Evaluation of Physical Barriers – TUB-1

Address: Located in the median of State Route 91 freeway

Evaluation Date: 07-19-2021

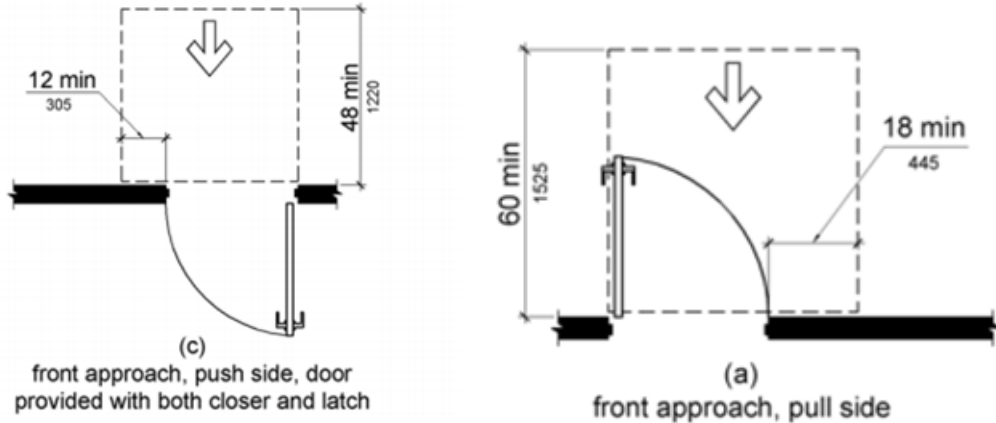
Issues/ Barriers Identified	Solutions	Comments/ ADA Requirements
<div data-bbox="164 163 385 197" data-label="Section-Header"><p>1. Entry Doors</p></div> <div data-bbox="211 258 1143 395" data-label="Text"><p>Maneuvering clearance for the main entry/exit door from inside is reduced by the fire extinguishing apparatus to 9 inches instead of the required 12 inches. Maneuvering clearance for the restroom door is also impeded.</p></div> <div data-bbox="211 431 1103 1016" data-label="Image"></div>	<div data-bbox="1196 258 1572 465" data-label="Text"><p>Relocate apparatus to provide maneuvering clearances required for exiting the space and for entering the toilet room. Or,</p></div> <div data-bbox="1196 504 1532 675" data-label="Text"><p>Provide automatic push button that can allow the doors to remain open in the power-off condition. Or,</p></div> <div data-bbox="1196 713 1572 957" data-label="Text"><p>A Personal Assistance Service (PAS) can be provided as a reasonable accommodation to enable an employee to perform the essential functions of their job.</p></div>	<div data-bbox="1600 258 2952 429" data-label="Text"><p>404.3.2 Maneuvering Clearance. Clearances at power-assisted doors and gates shall comply with 404.2.4. Clearances at automatic doors and gates without standby power and serving an accessible means of egress shall comply with 404.2.4. EXCEPTION: Where automatic doors and gates remain open in the power-off condition, compliance with 404.2.4 shall not be required.</p></div> <div data-bbox="1650 459 2520 828" data-label="Diagram"></div> <div data-bbox="1600 872 2685 905" data-label="Caption"><p>Figure 404.2.4.1 Maneuvering Clearances at Manual Swinging Doors and Gates</p></div>

<div data-bbox="164 1058 360 1092" data-label="Section-Header"><p>2. Exit Doors</p></div>		<p>Single entry/exit door. See above.</p>
<div data-bbox="164 1108 578 1143" data-label="Section-Header"><p>3. Exterior Accessible route</p></div>		
<div data-bbox="211 1177 1131 1278" data-label="Text"><p>The bottom sloped extension of the handrail at exterior stairs is reduced to 10 inches due to the post, instead of being equal to tread depth</p></div>	<div data-bbox="1196 1177 1479 1278" data-label="Text"><p>Compliant bottom rail extensions shall be provided</p></div>	<div data-bbox="1600 1207 2362 1723" data-label="Diagram"></div>
